Proj. No.: H0562C  
File Loc.: Westminster

California Regional Water Quality Control Board  
Central Coast Region  
895 Aero Vista Drive, Suite 101  
San Luis Obispo, CA 93401

**RE: REVIEW OF OLIN STATEMENT REGARDING NORTHEAST FLOW**

Attachment 2.3: Quarterly deep aquifer groundwater contour figures from Mactec 3rd Quarter, 2005; 4th Quarter, 2005; 1st Quarter 2006 and 2nd Quarter 2006 Reports.

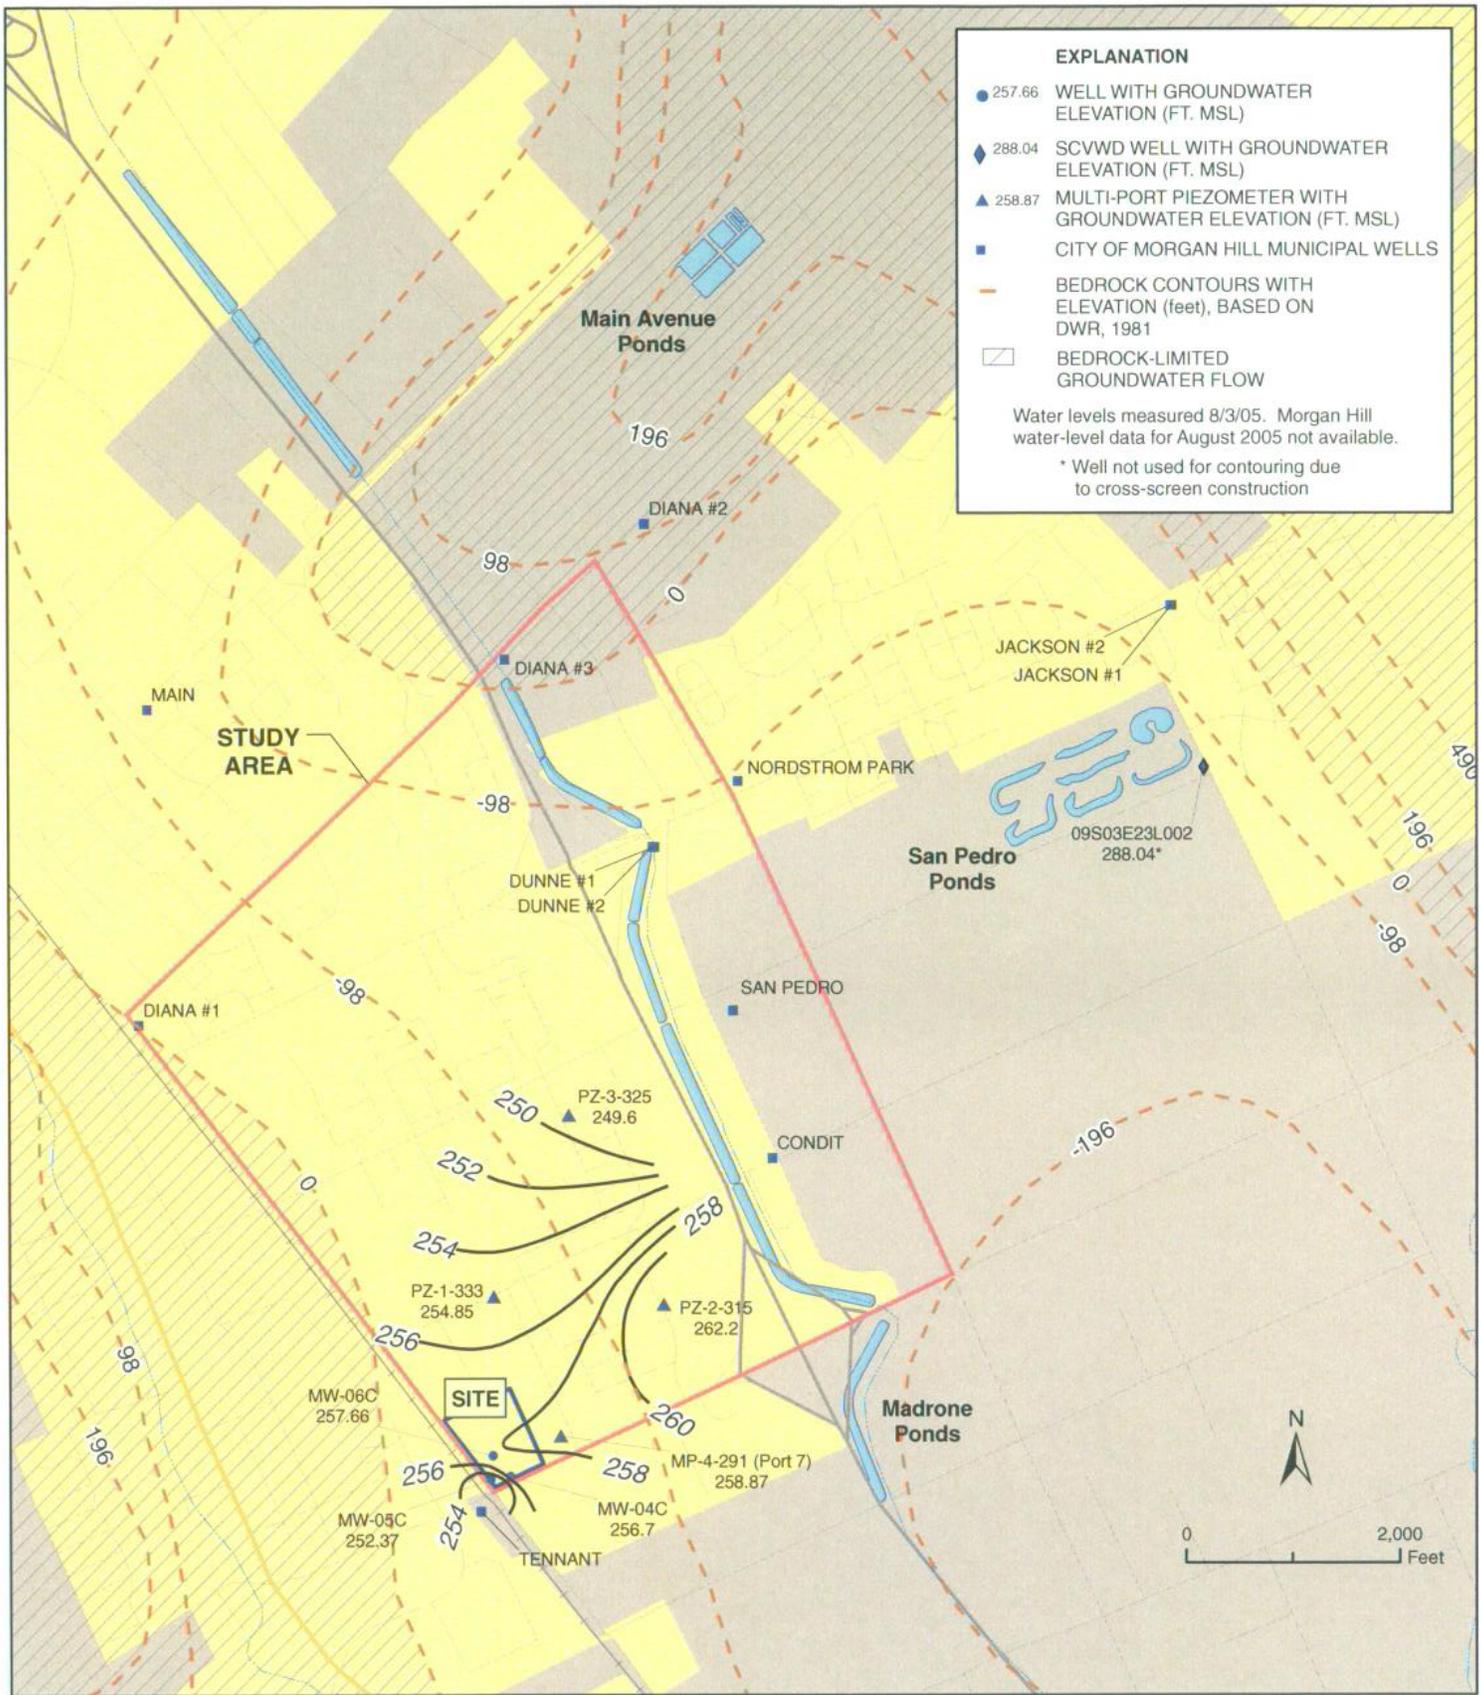
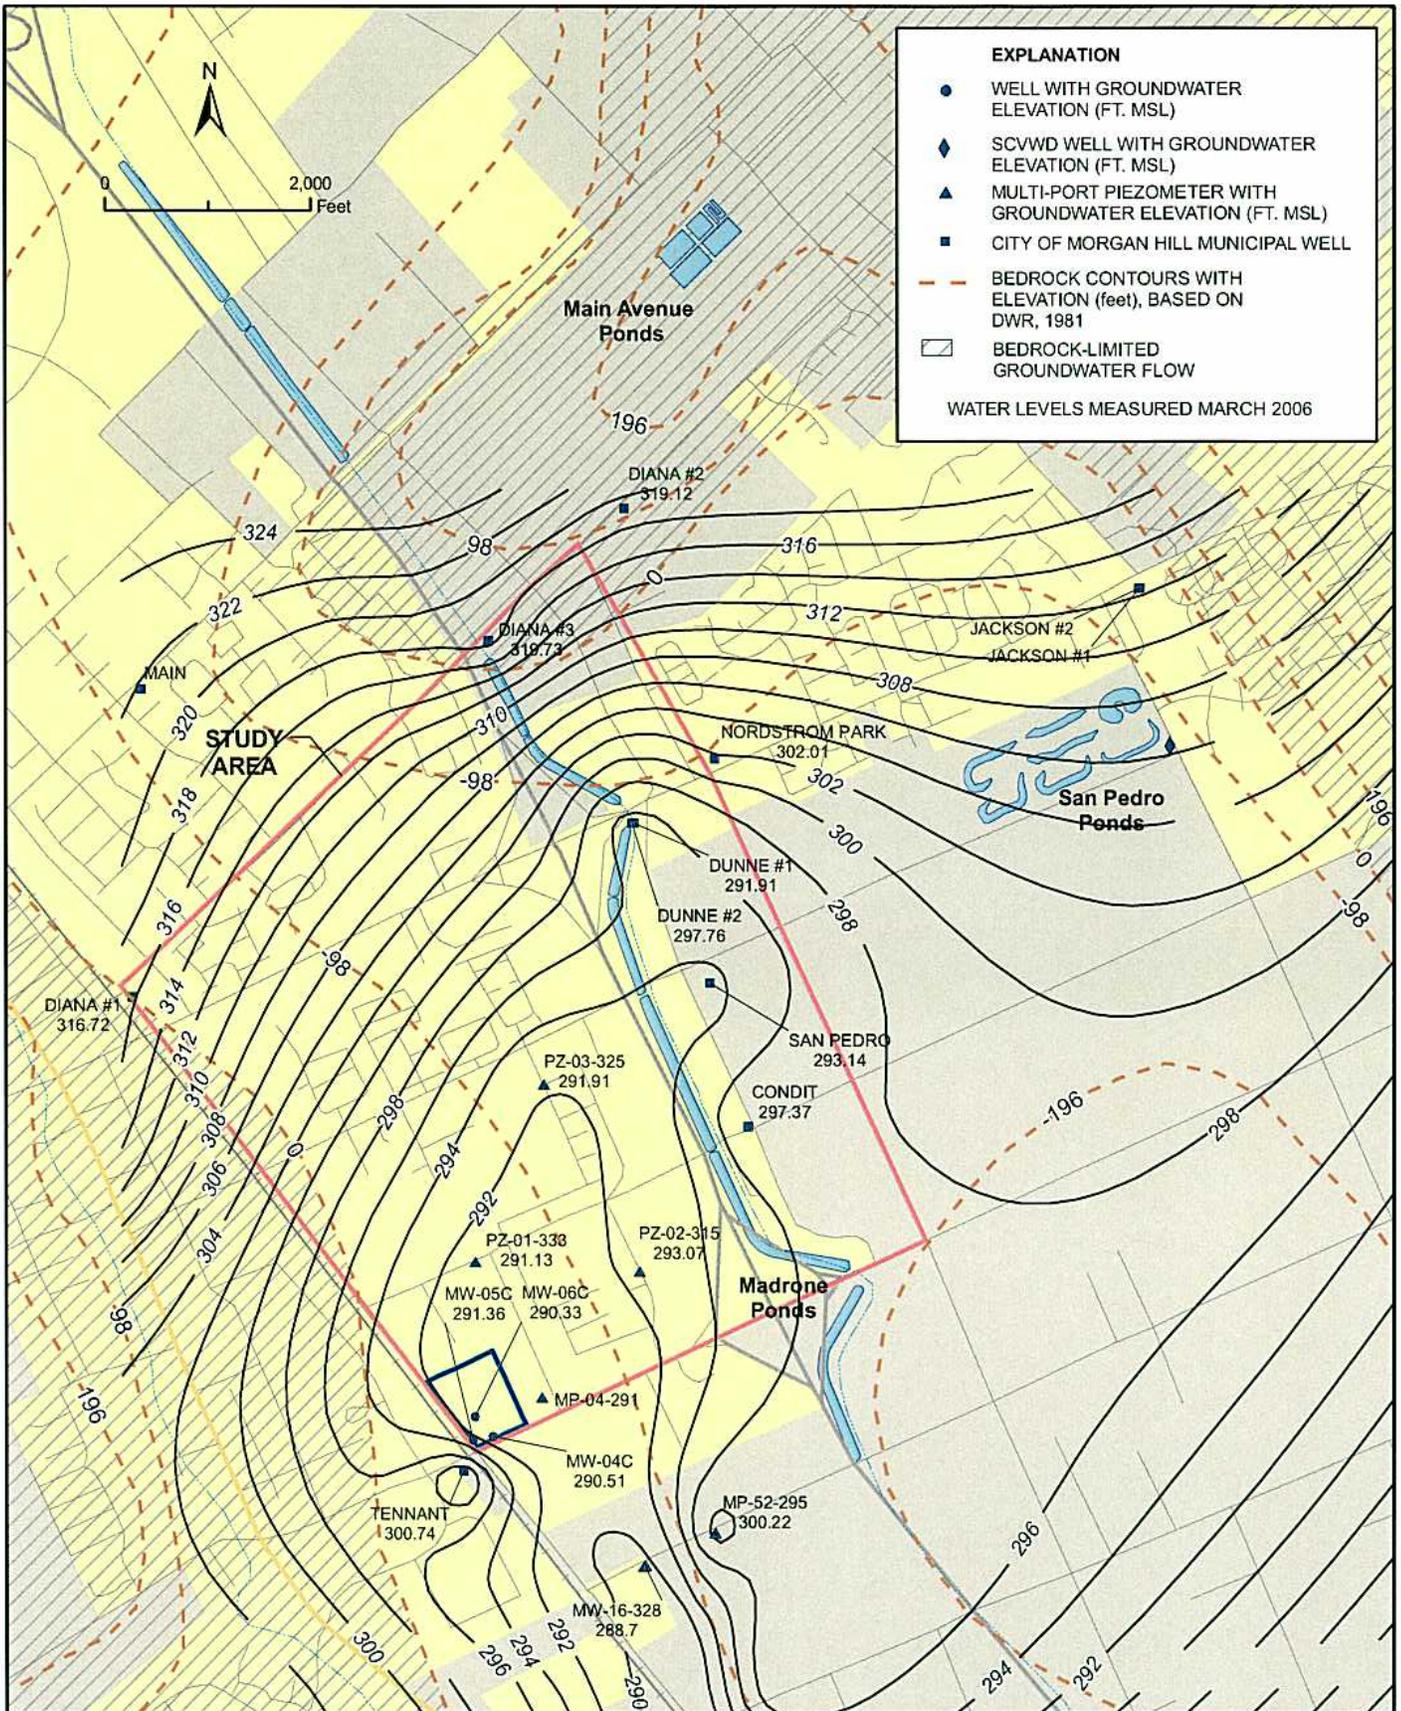
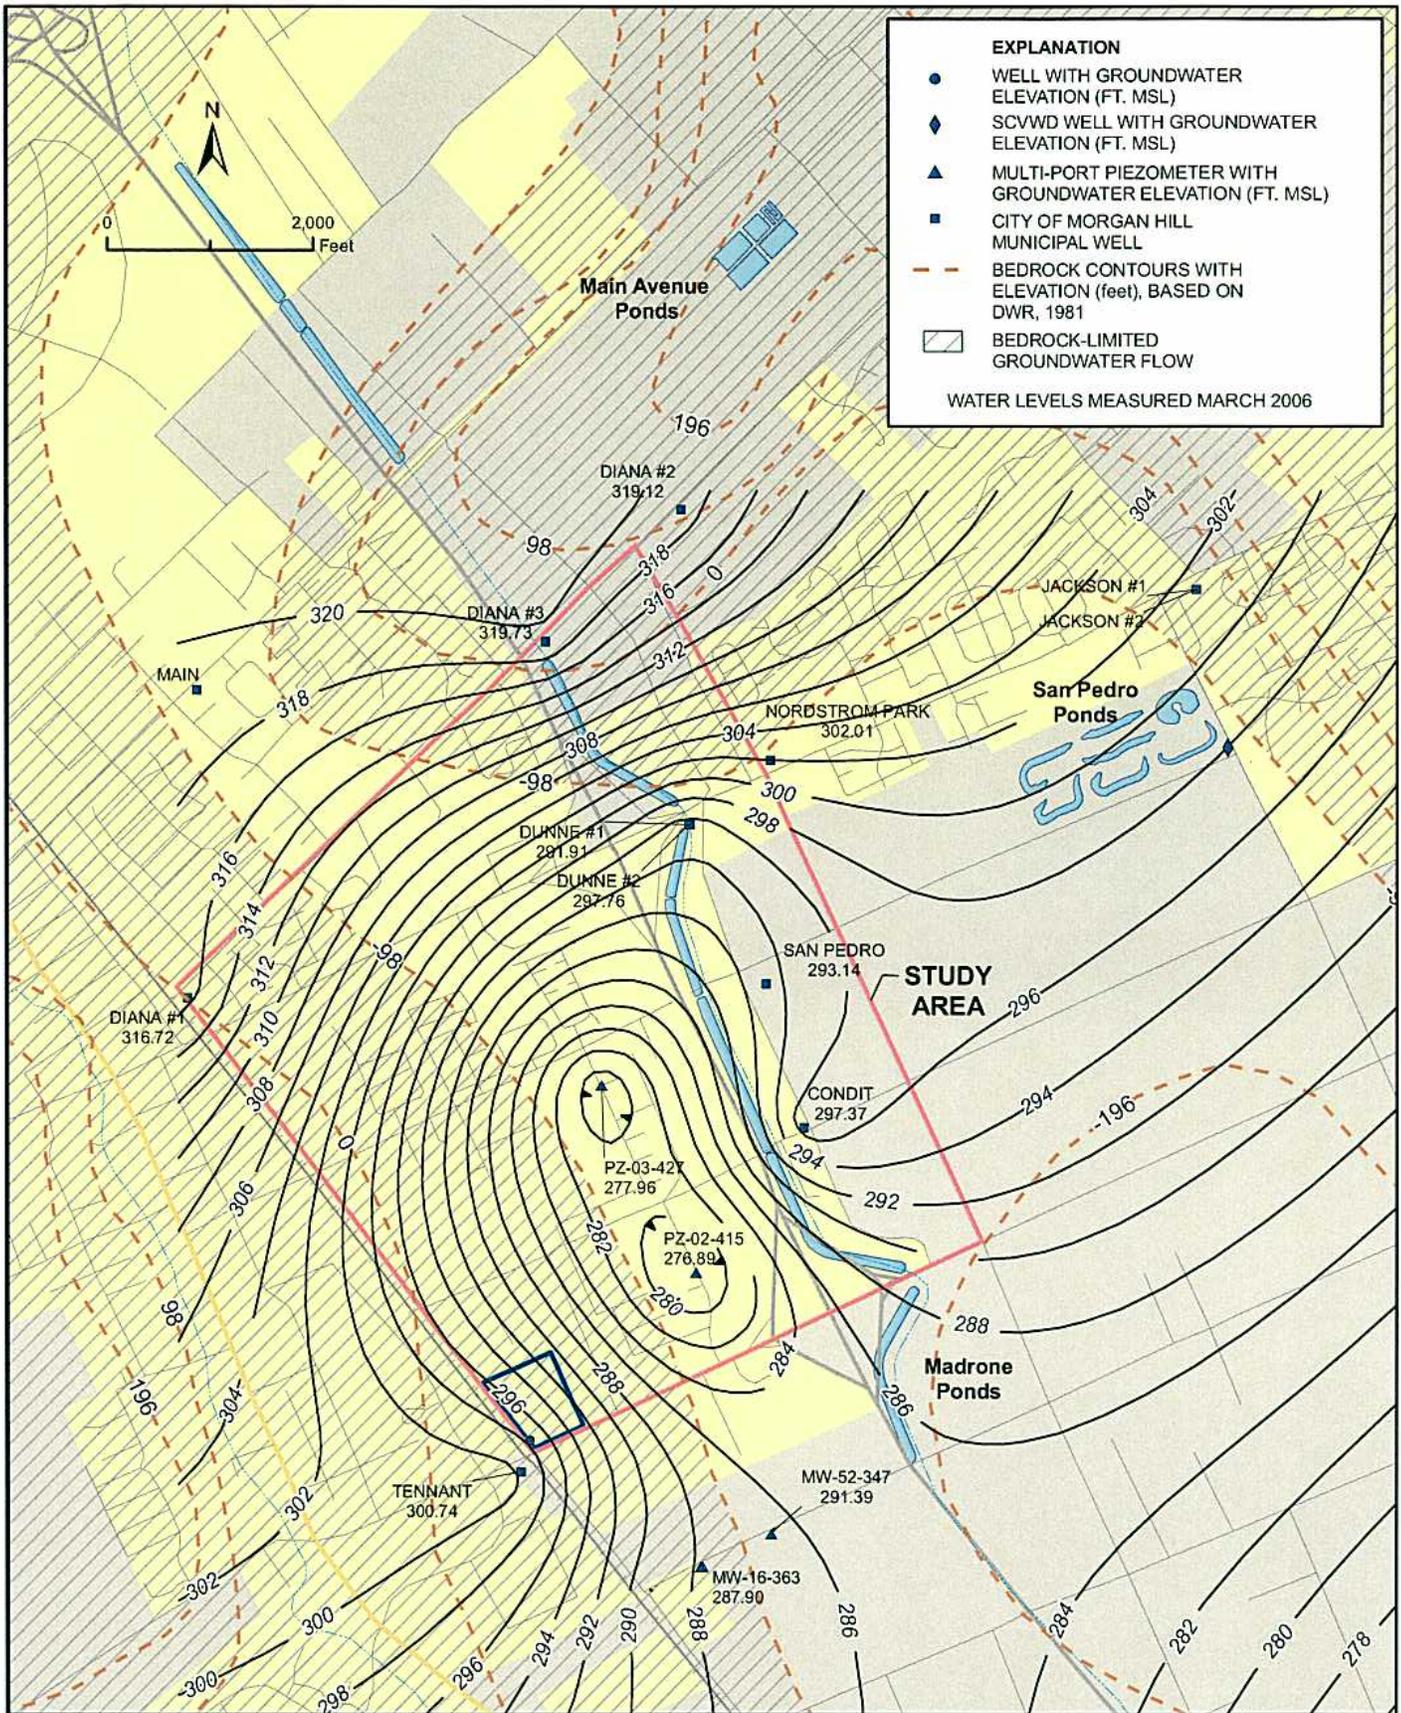
- c. Gradient maps generated by Olin's consultant showing north and northeasterly flow in the deep aquifer zone, using data from the northeast piezometers for one year, dating back to summer of 2005 in Attachment 2.3 (for Q3, 2005, Q4, 2005, Q1, 2006 and Q2, 2006); and,
